Town of Hilton Head Island

Design Review Board Meeting

**Fist African Baptist Church
70 Beach City Road
Final
Response Letter to Conditions
November 25, 2025
DRB-001095-2025**

**First African Baptist Church
70 Beach City Road
Final Set Plan Set
November 25, 2025
DRB-001095-2025**

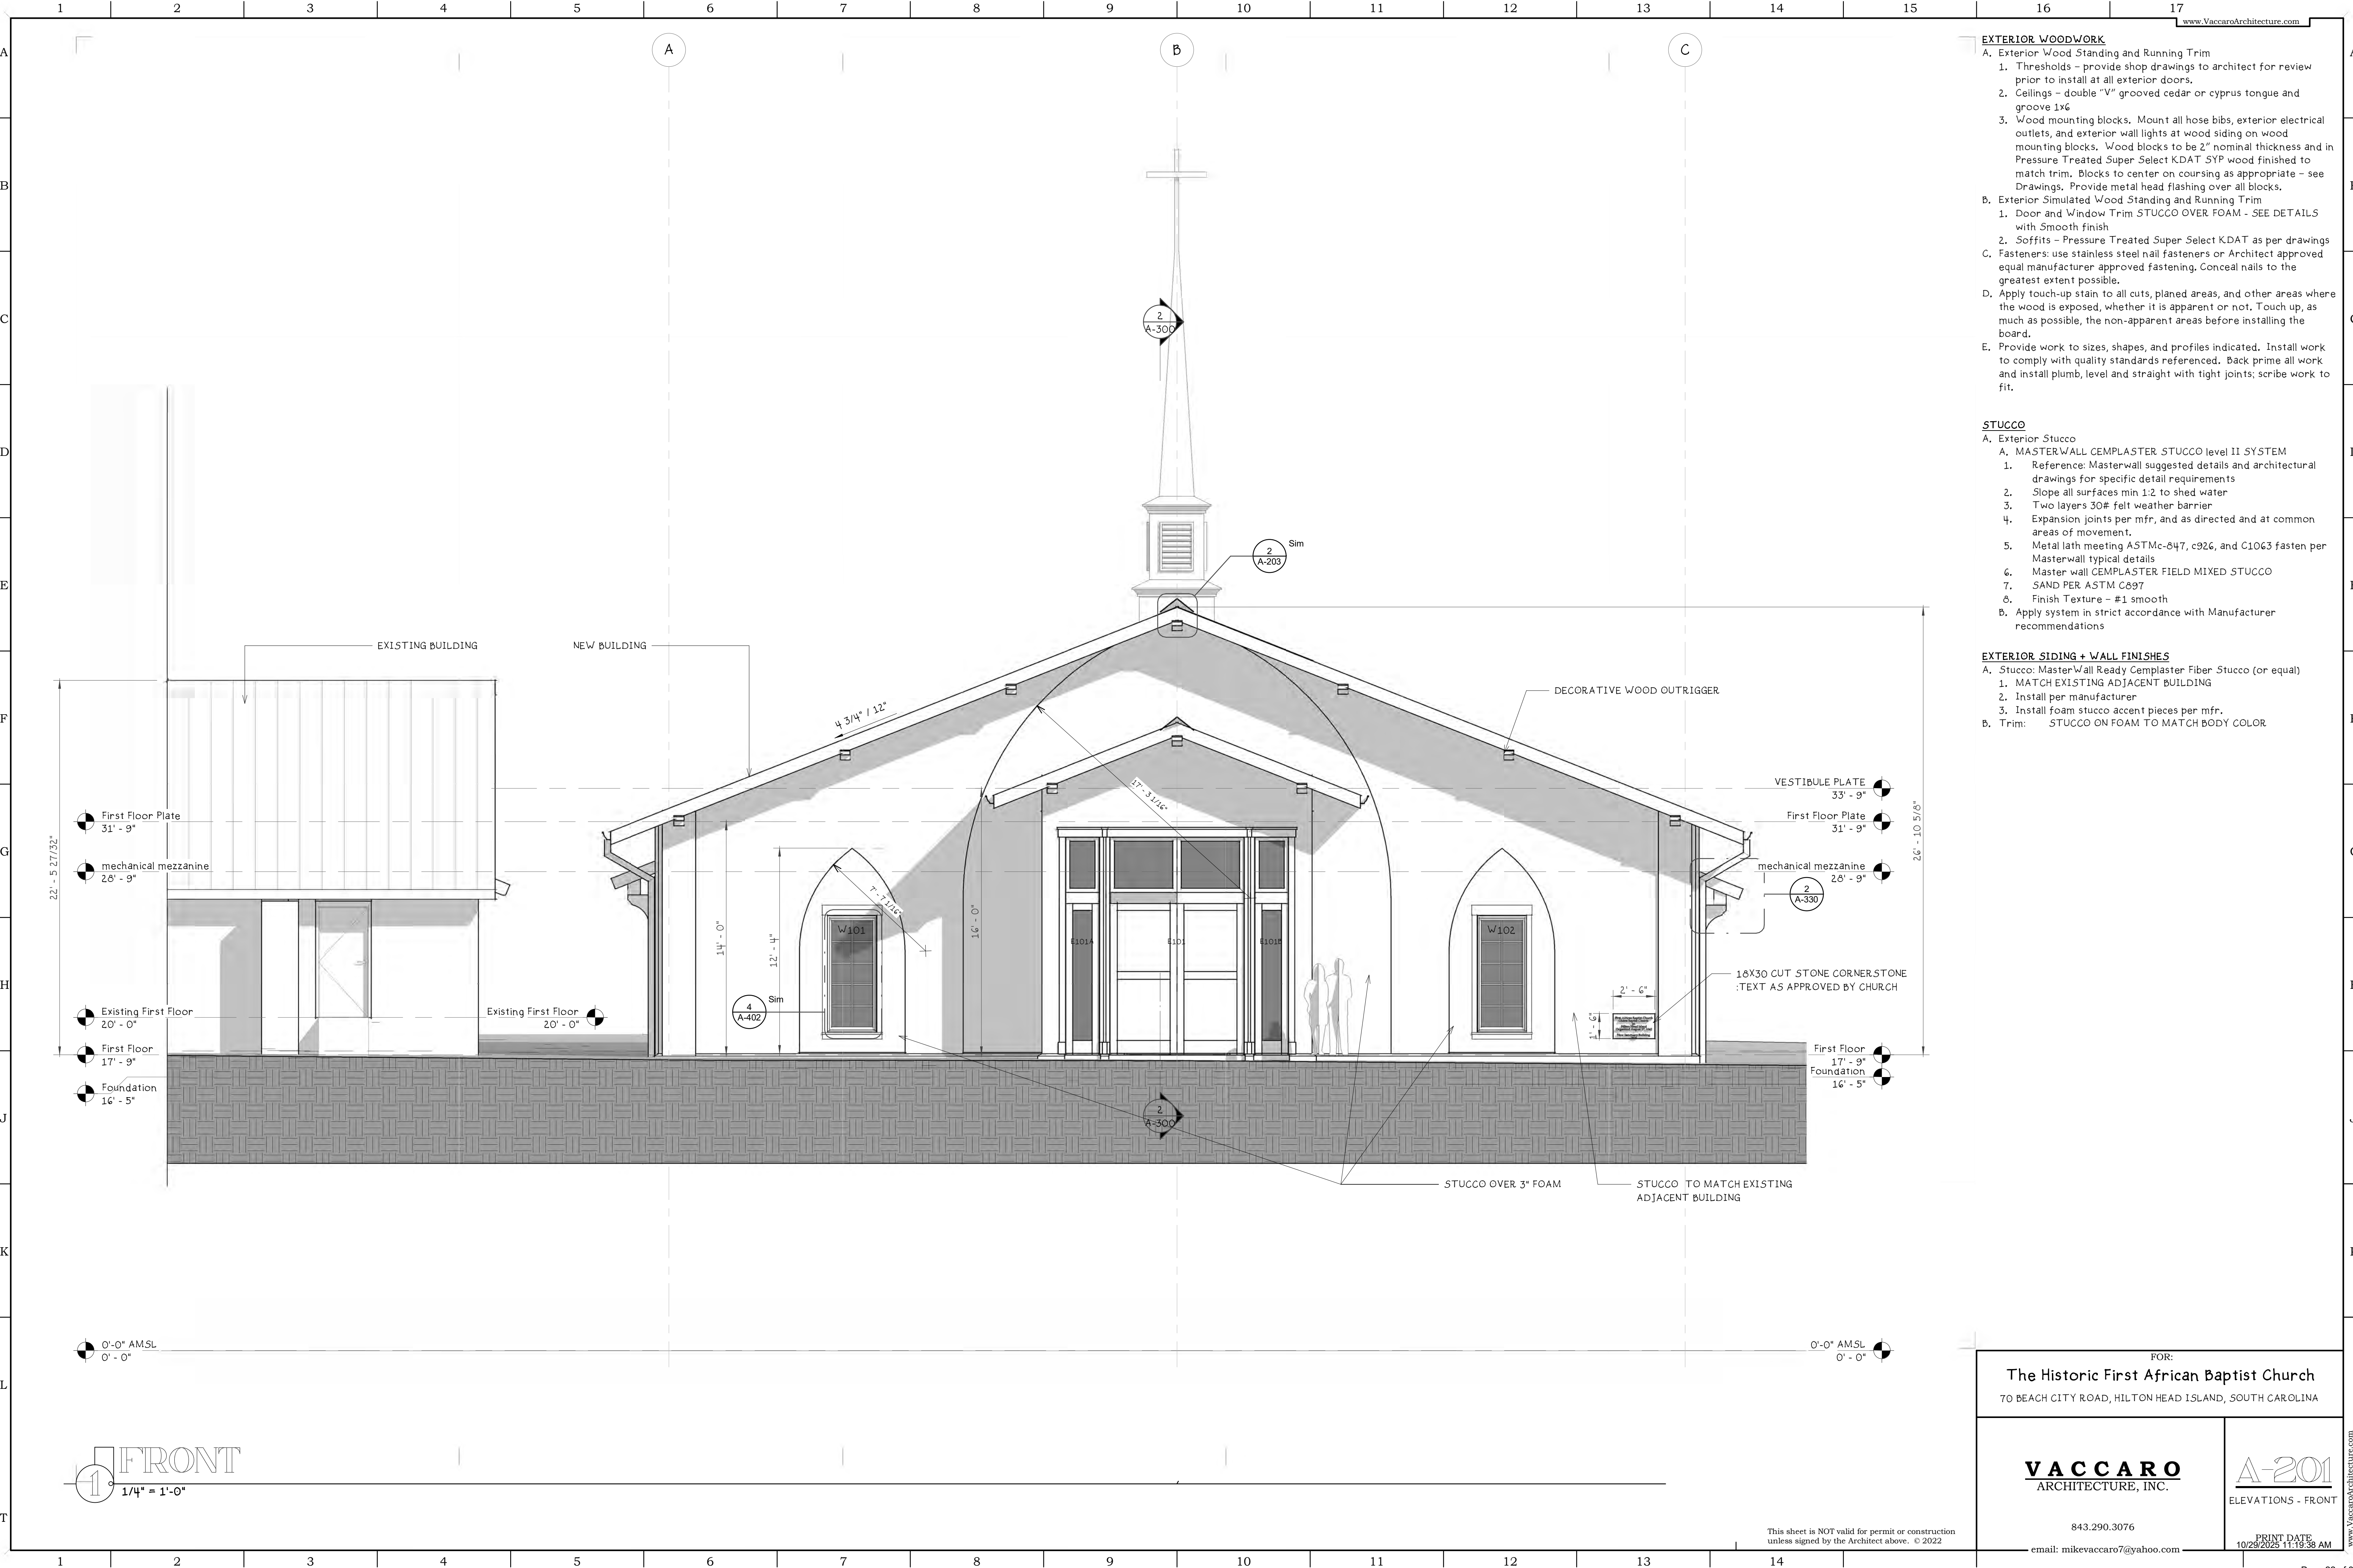
1. Study the proportion of the windows in comparison with the shutters.
 - a. Shutters were removed. All of the windows will be stained glass. Pilasters were added to in between the windows to match the existing building.

2. Show the downspouts.
 - a. Downspouts have been shown.
3. Study the addition of corner pilasters to be similar to the pilaster of the existing church.

- a. Corner pilasters have been added.
4. Show the existing church in elevation with the proposed sanctuary for comparison with the correct floor elevations on both.
